PB-MGE02-05 US

Product Bulletin – Aluminum Structural Framing

VarioFix Block Part Number Changes

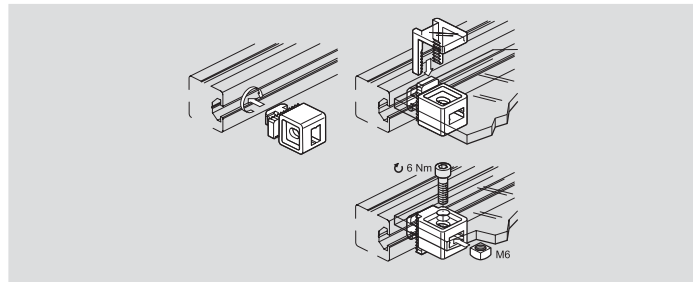
3 842 529 287 10 mm VarioFix Block has been replaced by **3 842 529 239** and **3 842 184 738**

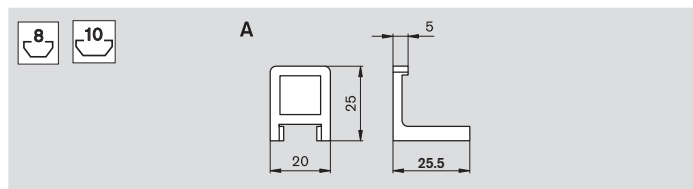
3 842 506 267 8 mm VarioFix Block has been replaced by **3 842 535 696** and **3 842 184 738**.
